工程指示 / 要求簡箋(E.I.)

工程指示編號：EI / 578 / 23

工程名稱：將軍澳日出康城 11

工程項目：幕牆 單元件 地盆顧問報告 3/2 ~ 22/2

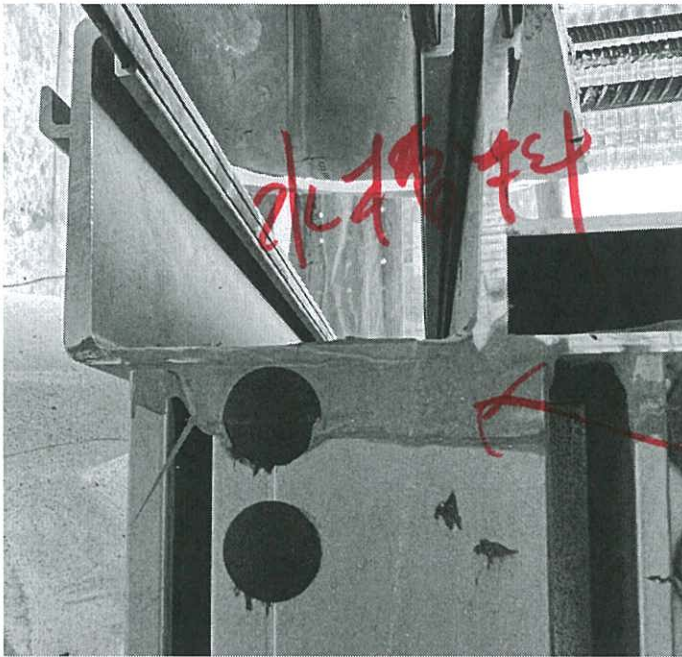
1. It was observed that the backpan fixing angle will block the unit installation work, please refer to attachment and provide the modification method at factory for it.
2. It was observed the transom with mullion joint was applied with excessive sealant, it will lead to new installed pane cannot descend due to these sealant. Please coordinate with factory assemble work to avoid/remove excessive sealant.

② 已通知廠作改善

① (已通知廠, 本地區前, 廠改好擋板)

Photo 2

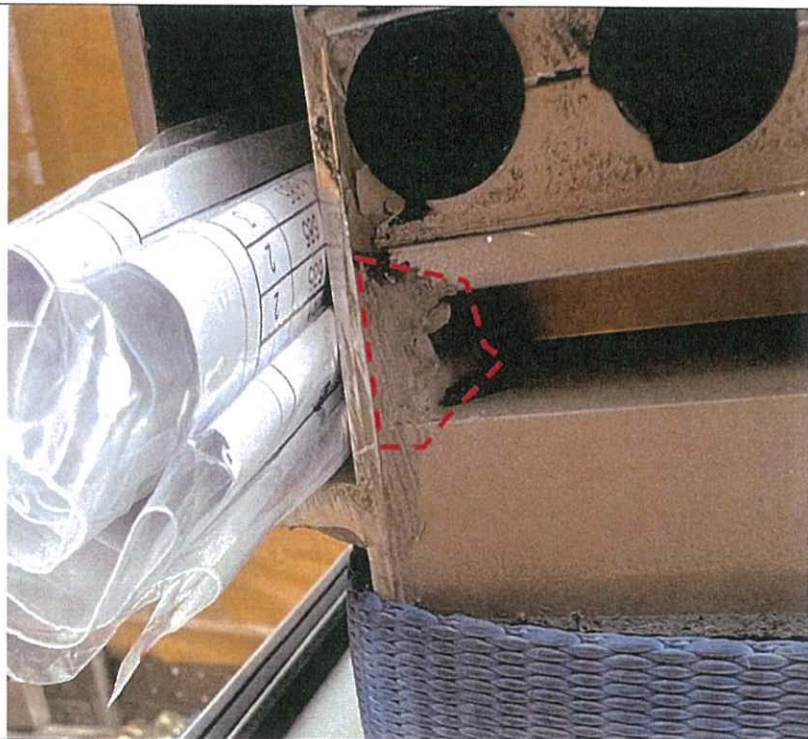
Description:
This transom joint head was observed to be applied with excessive sealant which may affect the unit installation.

Midi: 廠唧膠量減少，避免有機會影響安裝。

Photo 4

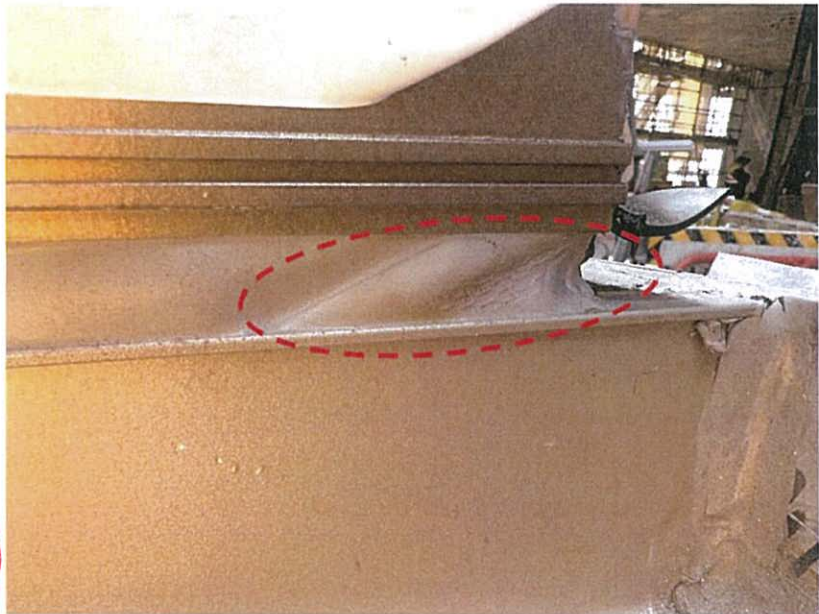
Poor applied sealant was observed at the joint position between transom and alum. cladding.

Midi: 已通知廠改善手工。

* 係咁樣做膠手工

Photo 4

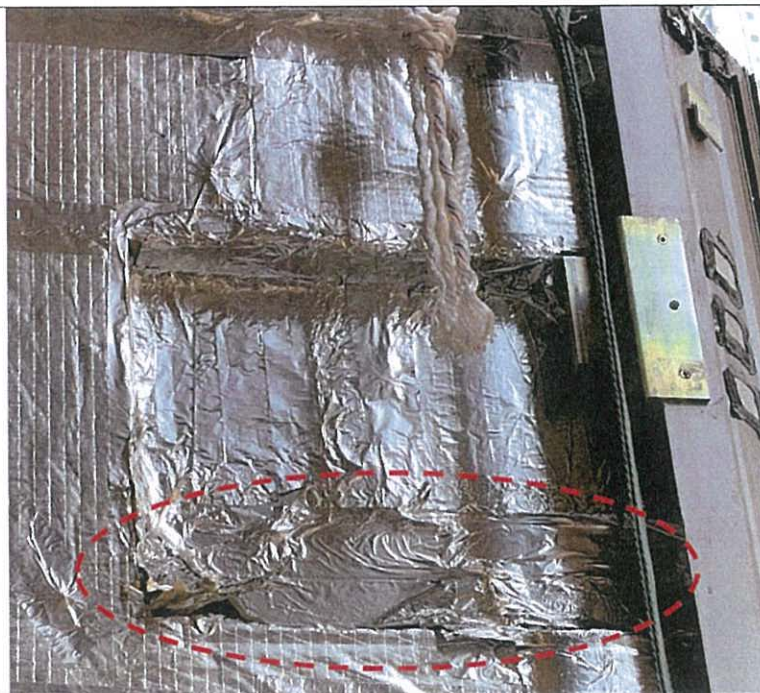
Part of the thermal insulation was observed to be cut off due to room limited during installation. This happened several times and please MIDI coordinates with factory for optimization of unit material fabrication size.

Photo 8

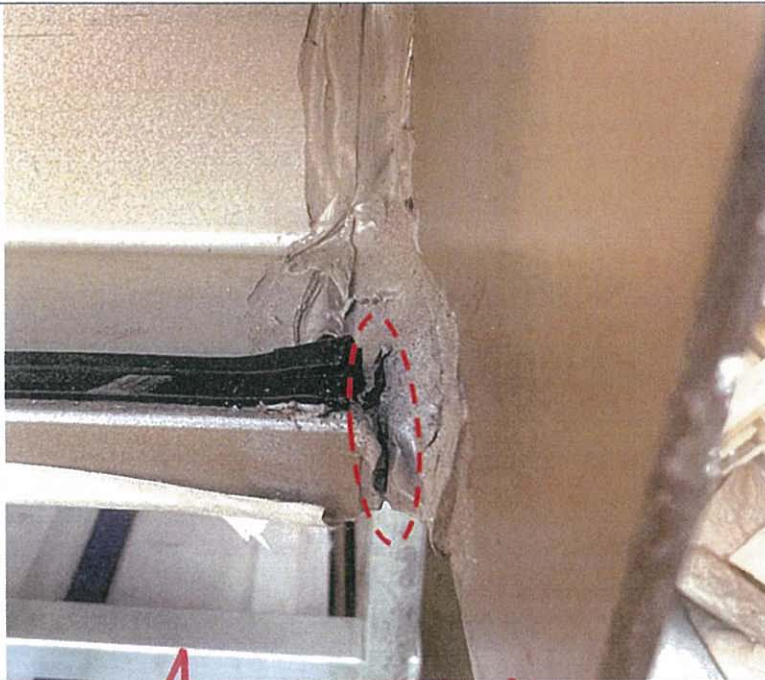
Sealant crack was observed due to end plate deformed. Please revise this and improve the protection during delivery.

Midi: 已補膠。
